WAYZATA CITY COUNCIL
Meeting Agenda

a. Consider Resolution 35-2023 Denying Rezoning, CUPs for Joint Parking and First Floor Multiple Family Dwellings, Shoreland PUD/CUP and SIP/CUP, and Project Design at 200 Lake Street East

c. Consider Resolution 35-2023 Denying the Rezoning, CUPs for Parking and First Floor Residential, Shoreland PUD/CUP, Shoreland Impact Plan/CUP, and Design Review at 200 Lake Street East

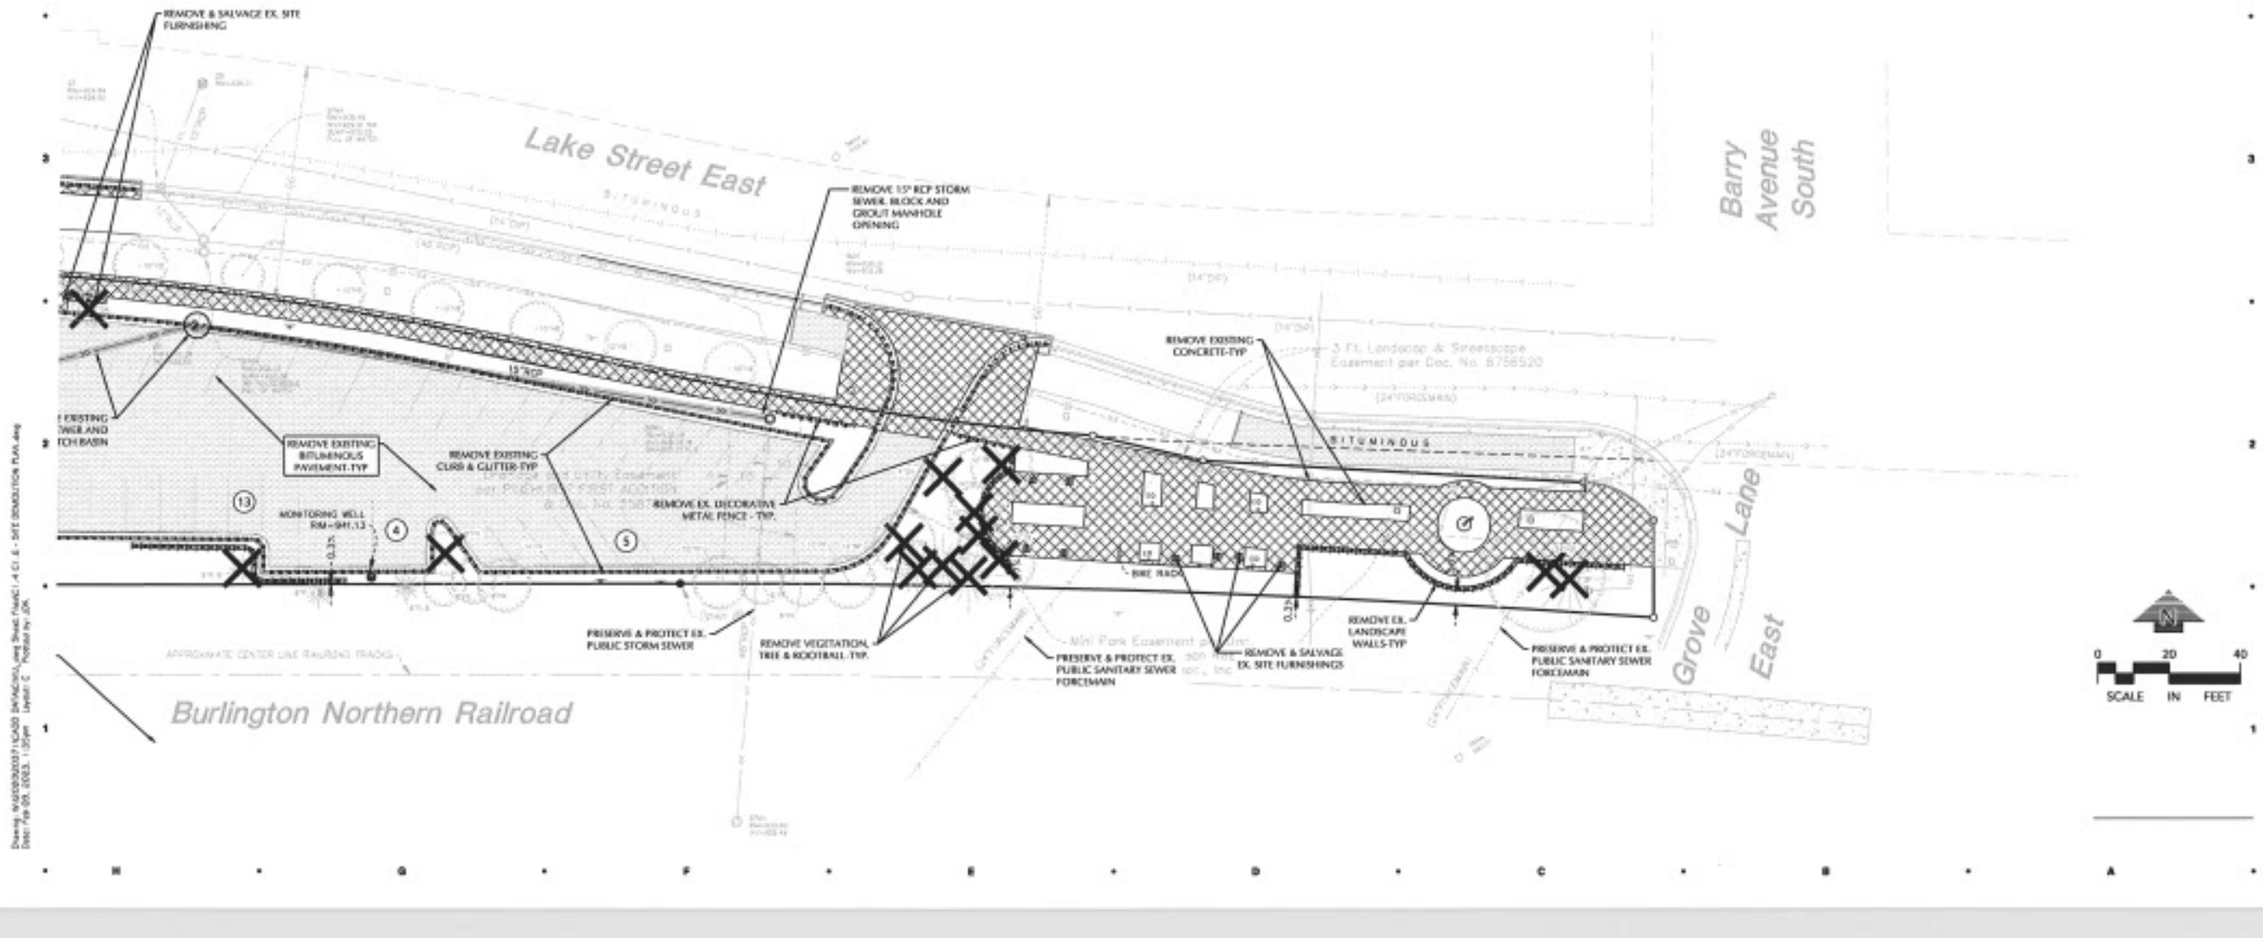
C1.6
. Can the bituminous trail segment at the east end of the project be protected? Based on proposed conditions why this would need to be removed. See additional comments on sheet L2.

LANDSCAPE PLAN AND TREE SURVEY + INVENTORY

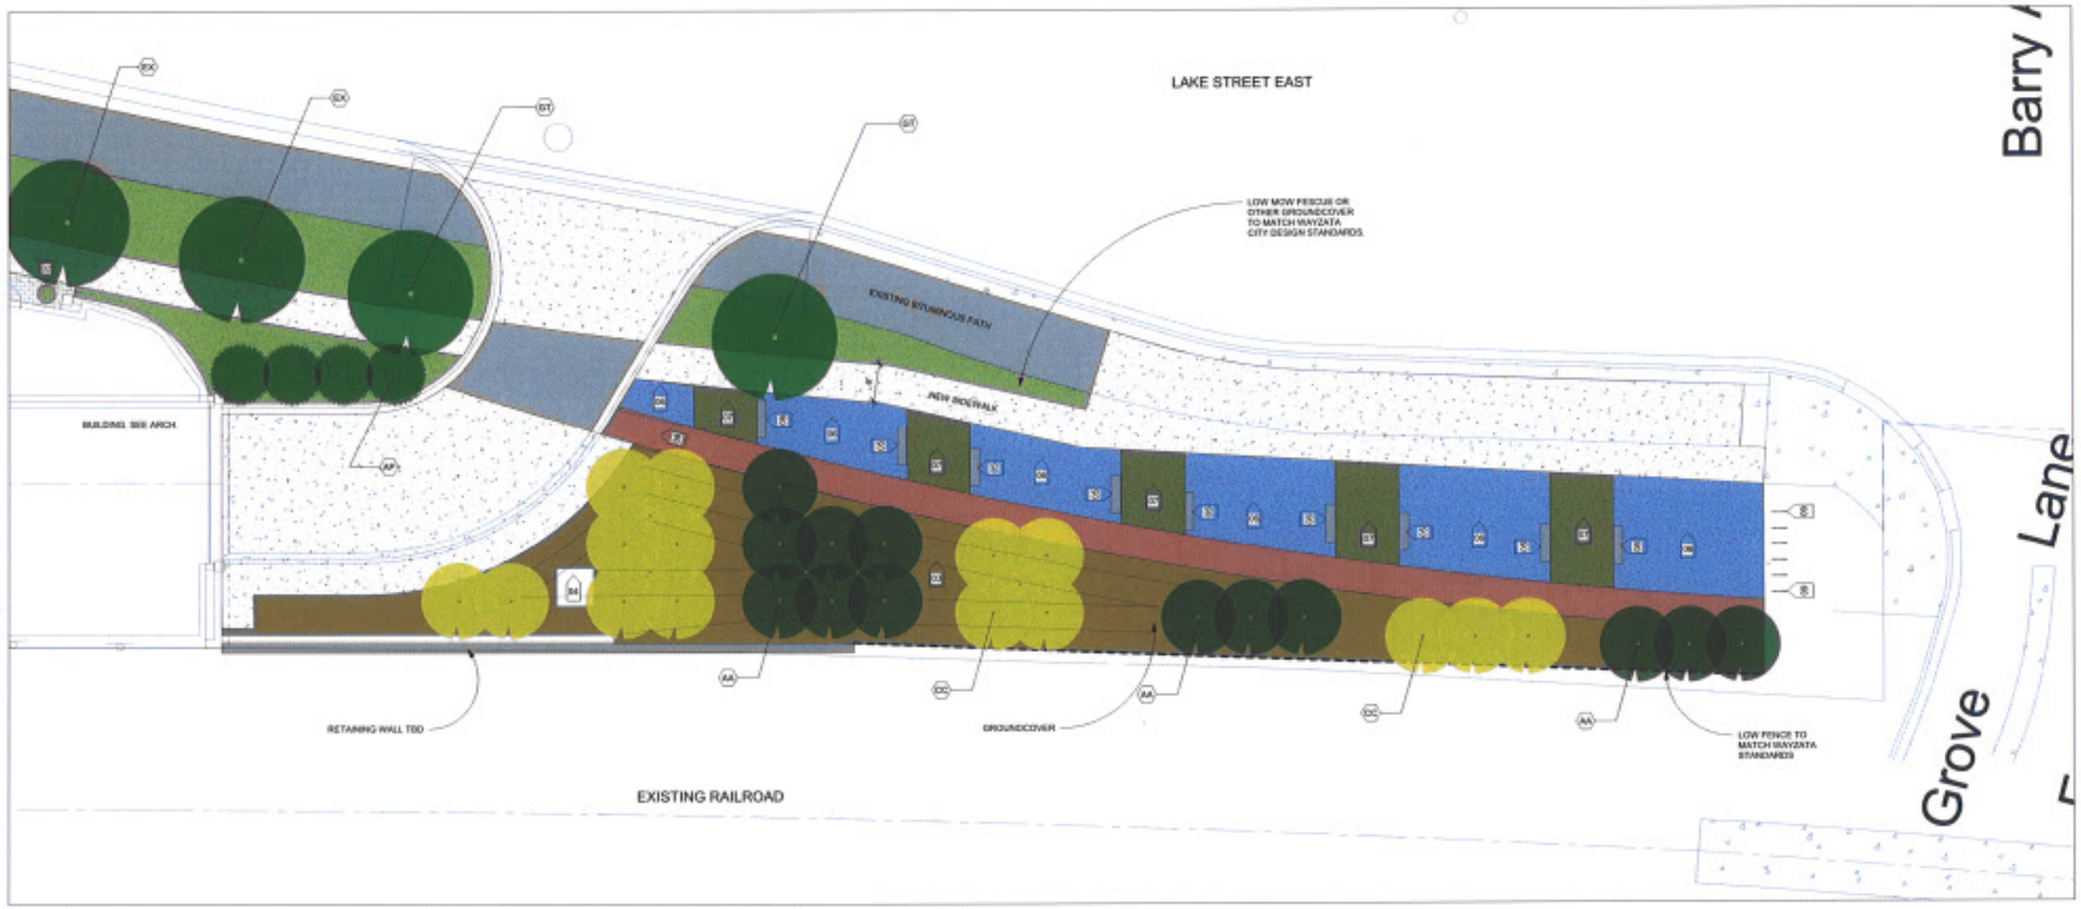
L2
. Bike racks at east end of the project are floating in a non-paved area (pavement was removed on demolition plan). Need to add pavement back.
. Plans show the bituminous trail segment between the driveway curb cut and Barry Ave needs to be demolished. Would prefer it remains. Even if it has to be demolished, would still like to see a separate regional trail from the pedestrian sidewalk, rather than the new sidewalk merging in with the trail. The renderings on sheet L3 seem to indicate this separation, even though the plans do not show it.
